From: Enya Fogarty
Sent: 17 July 2023 09:19
To: Planning Planning
Subject: FW: Objection to 2023/2245/P
Attachments: Daylight Sunlight Overshadowing Report - Grounds for Objection.pdf;
Updated Core Objections to Drury Works.docx

Core objections to planning scheme 2023/2245/P

redevelopment of the office block at 160-161 Drury Lane London WC2B 5PN.

Planning Application - 2023/2245/P
Proposed Development at 160-161 Drury Lane London Camden WC2B 5PN
Impact on Parker Street & Drury Lane Residents

Neighbouring Windows

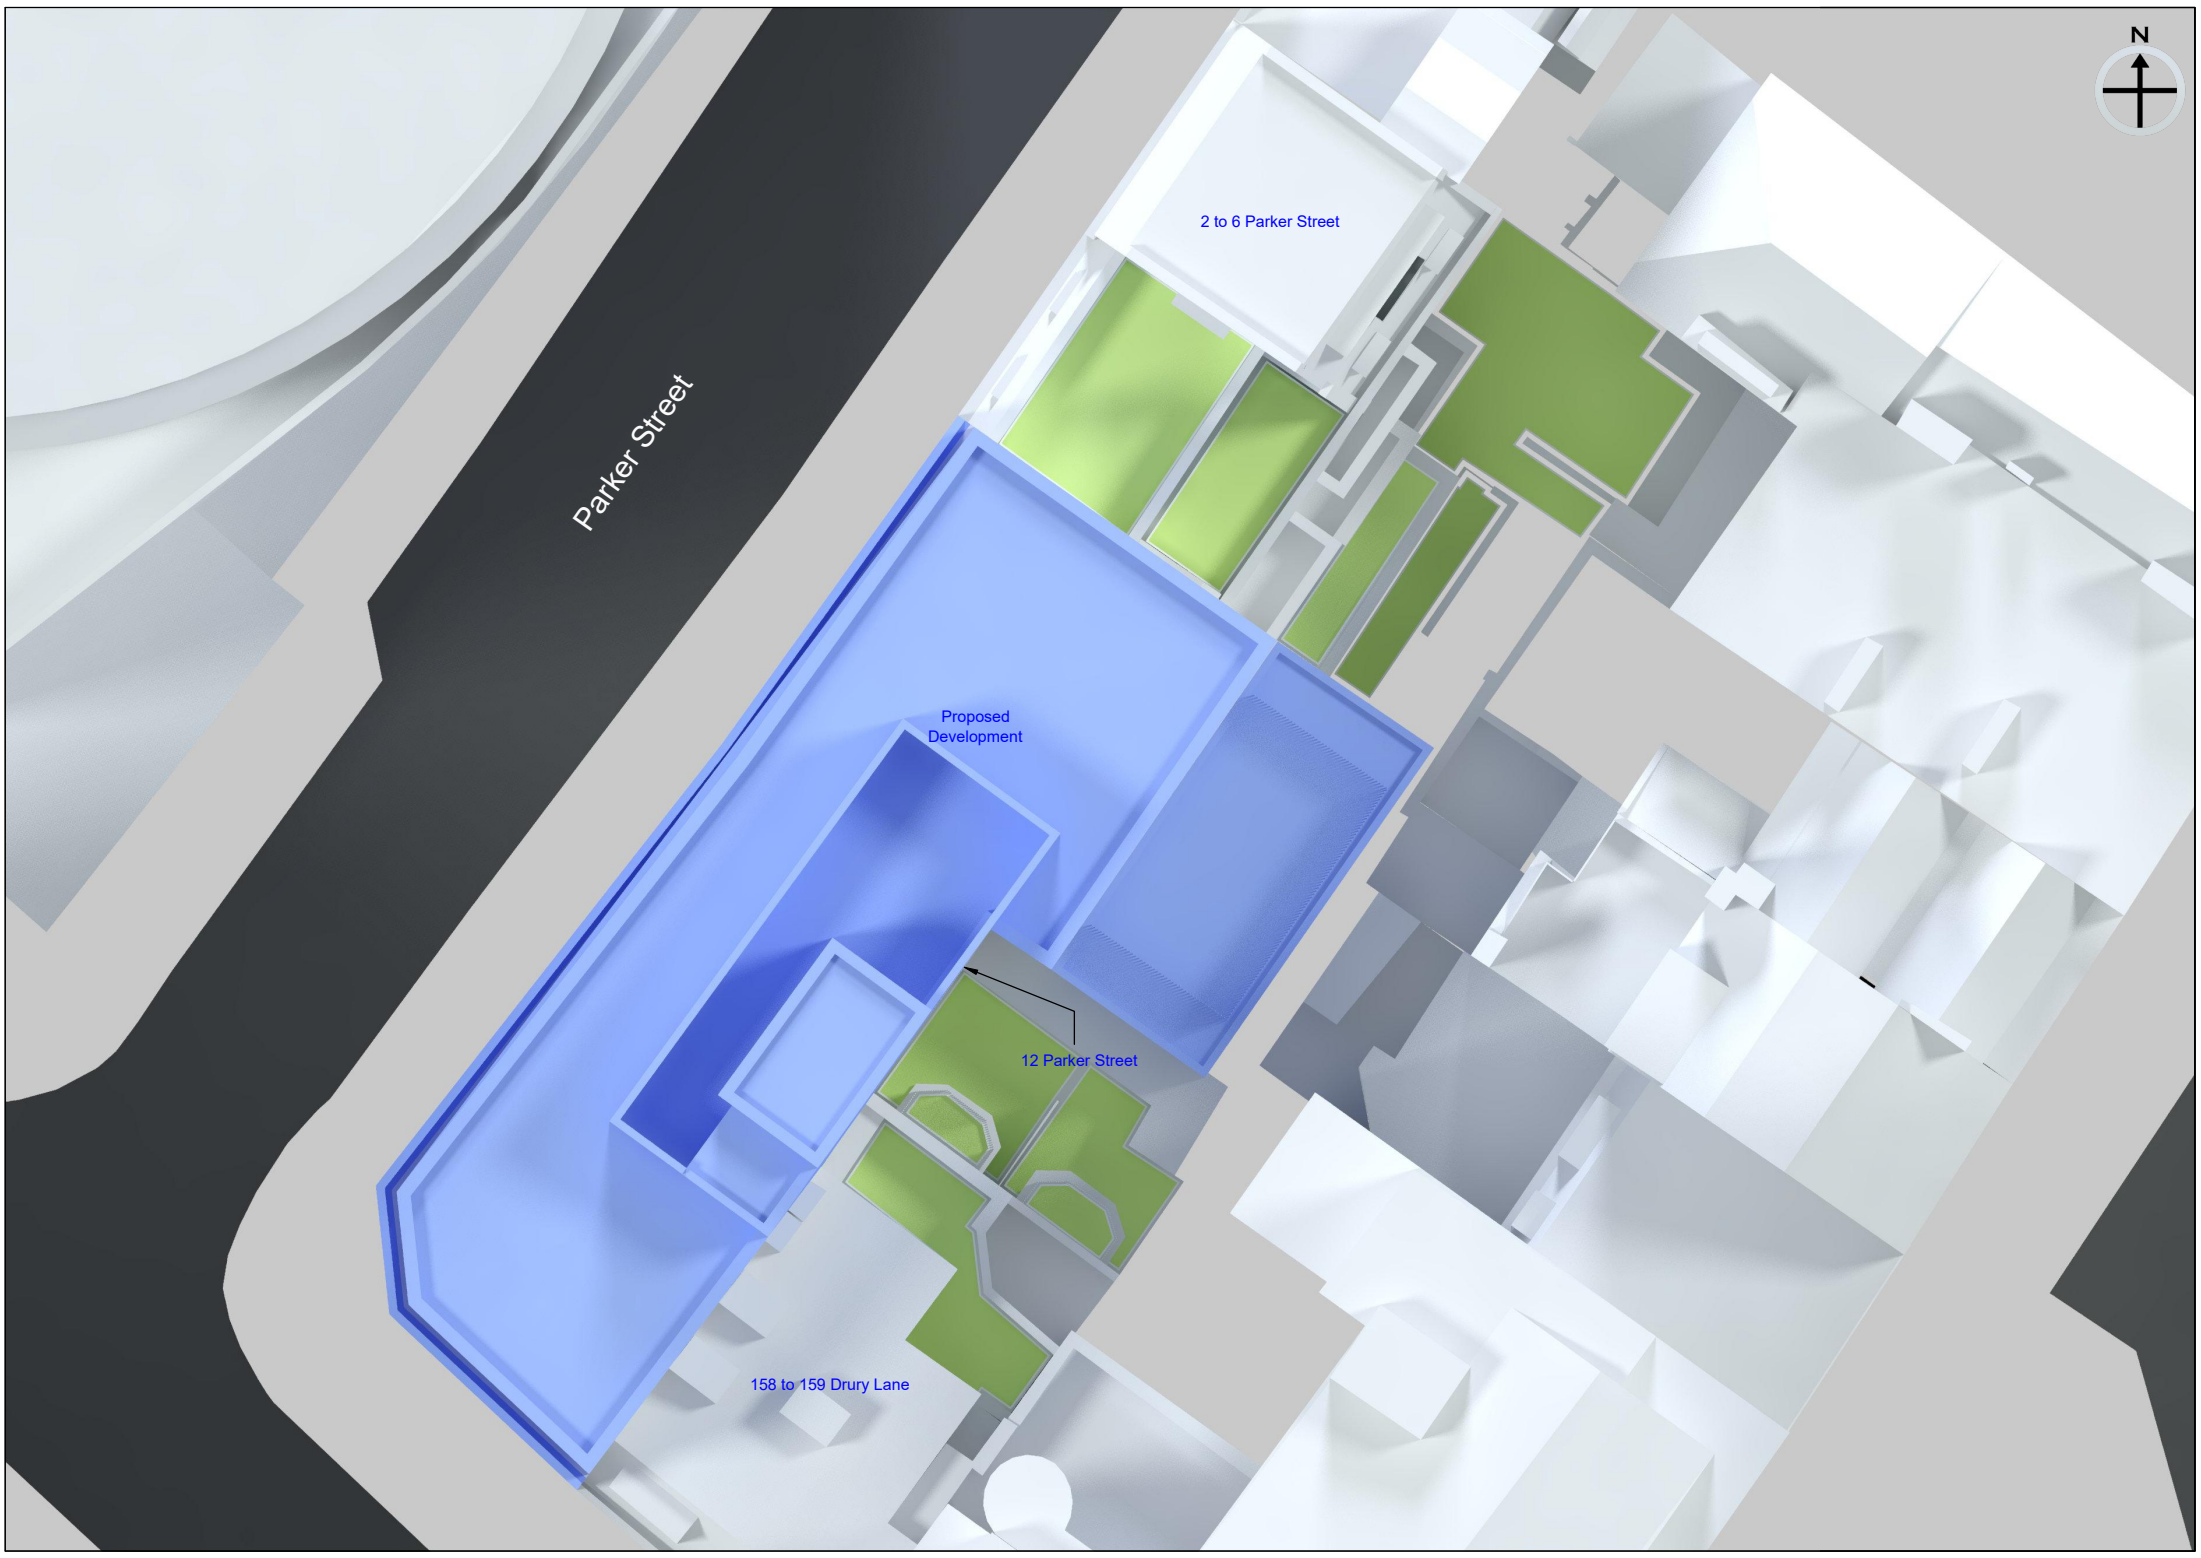
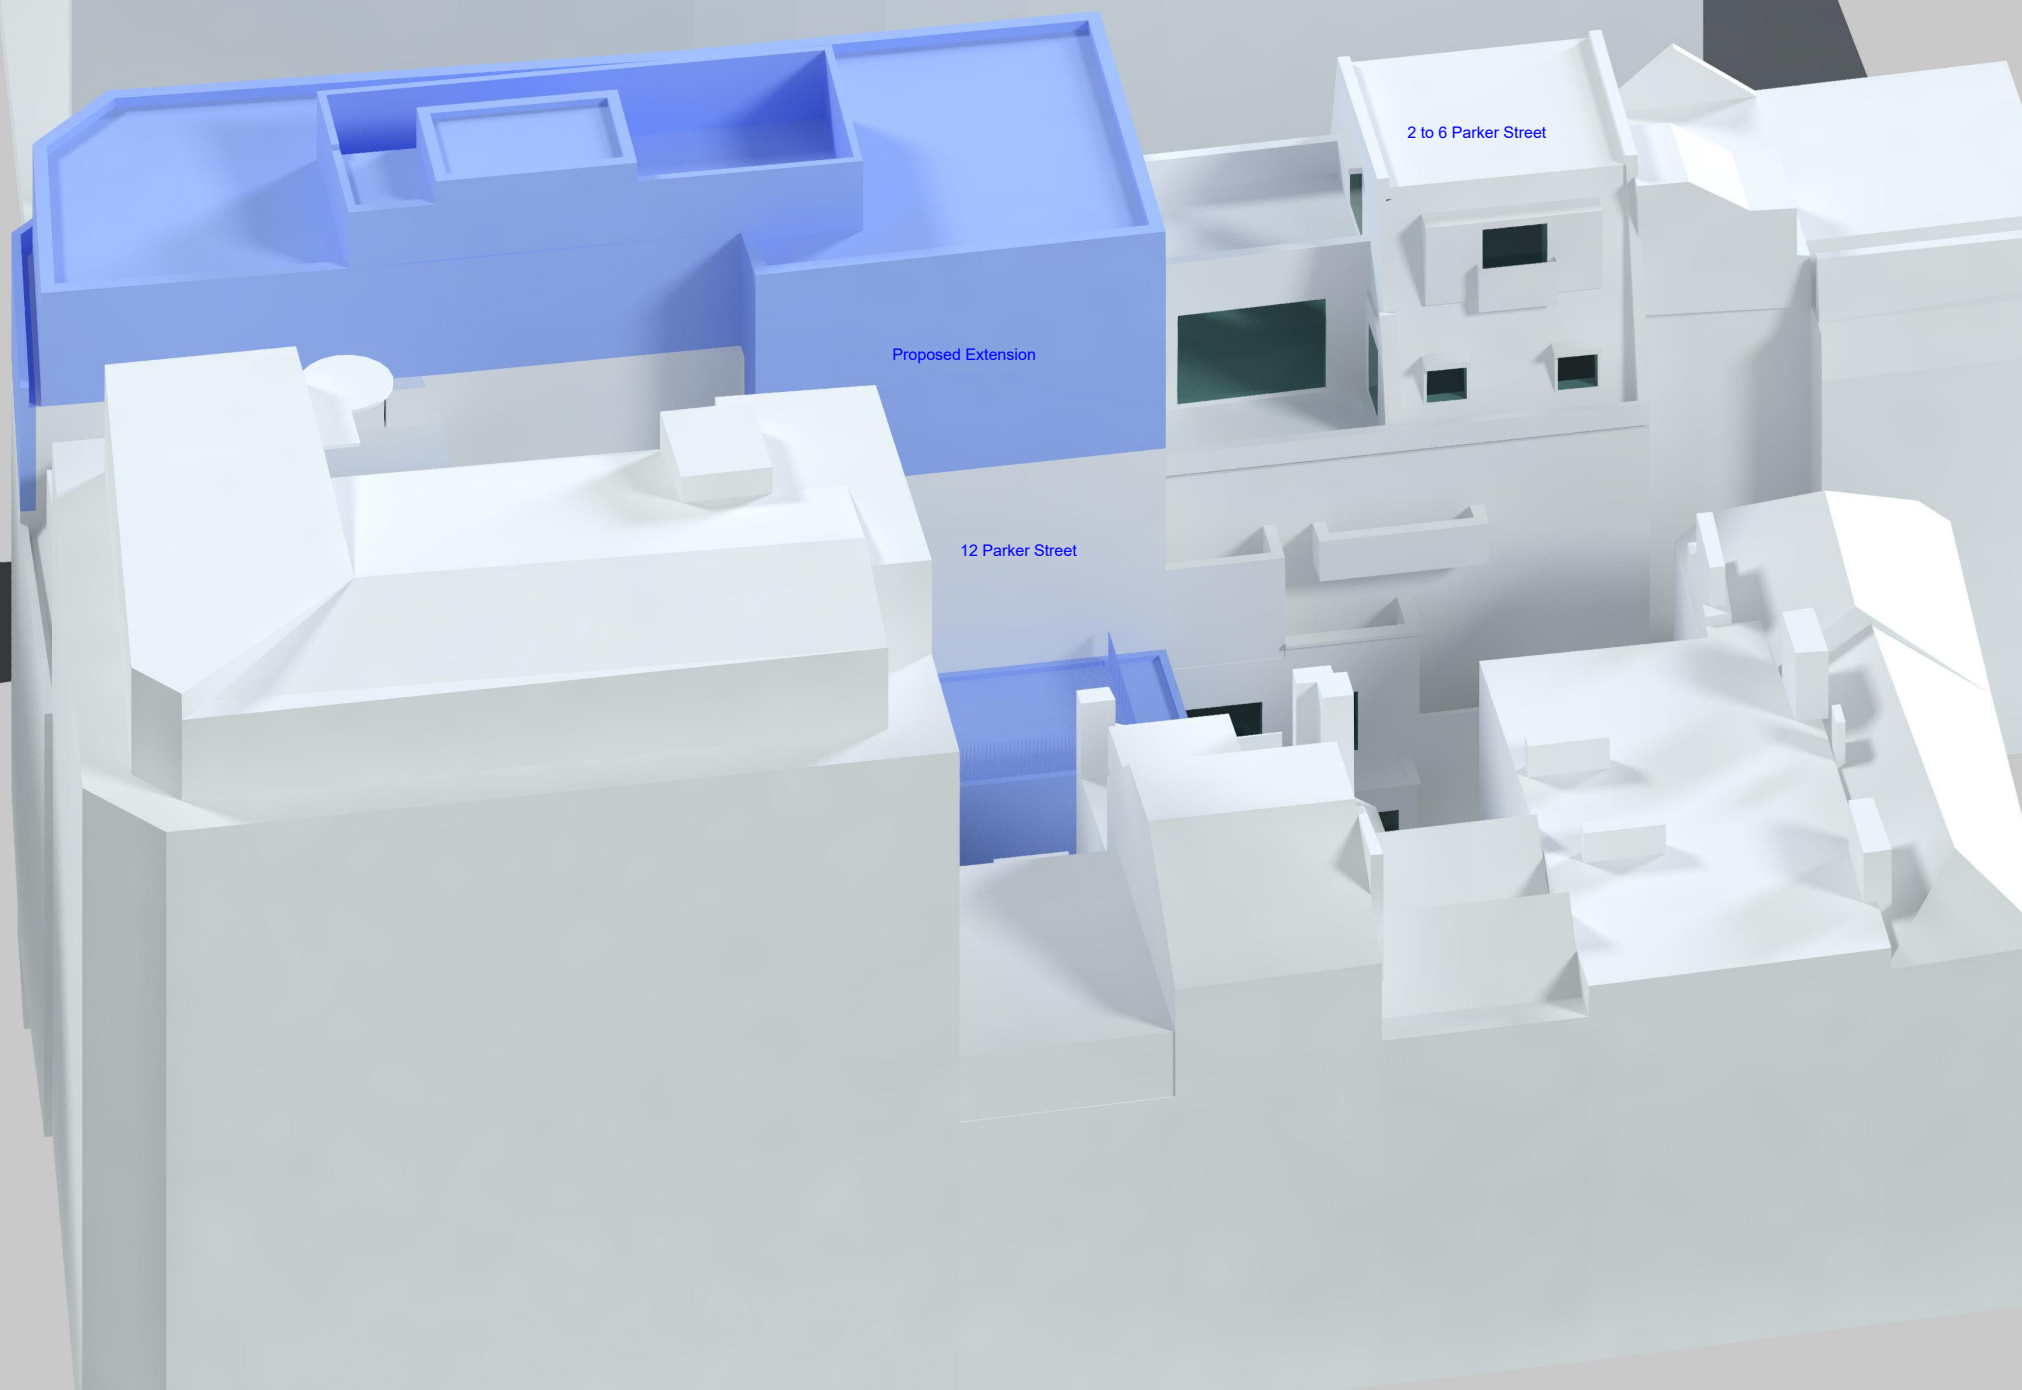
At section 8.24 – Point 2 states that both windows W6/254 [Window 11] (4th floor) & W1/255 [Window 16] (5th floor) are within 10% of the 0.8 permitted ratio loss. However, there is a significant difference between our results for W1/255 [Window 16] (5th floor primary window leading in the terrace) and those of Point 2. Our results confirm that the window serving the Studio is both greater than 10% within the 0.8 permitted ratio loss and significantly less light following the development in absolute terms. Our results are as follows: a VSC of 23% before the development and 15.7% after the development [7.3% absolute loss & 32% relative reduction in formerly enjoyed light] whereas Point 2's report states that the window has a VSC of 32.28% before the development and 23.68% after the development 8.6% absolute loss & 26.64% relative reduction in formerly enjoyed light].

The results of our analysis have revealed an additional transgression of the BRE Guide not identified within Point 2's report. Namely, window 31 in Flat 5 on the fourth floor of 158-159 Drury Lane. The window enjoys a VSC value of 23.9% before the development, which is reduced by 5.1% down to 18.8% after the development which is equivalent to a 21% loss of the formerly enjoyed daylight to this window. This represents a material loss of light.
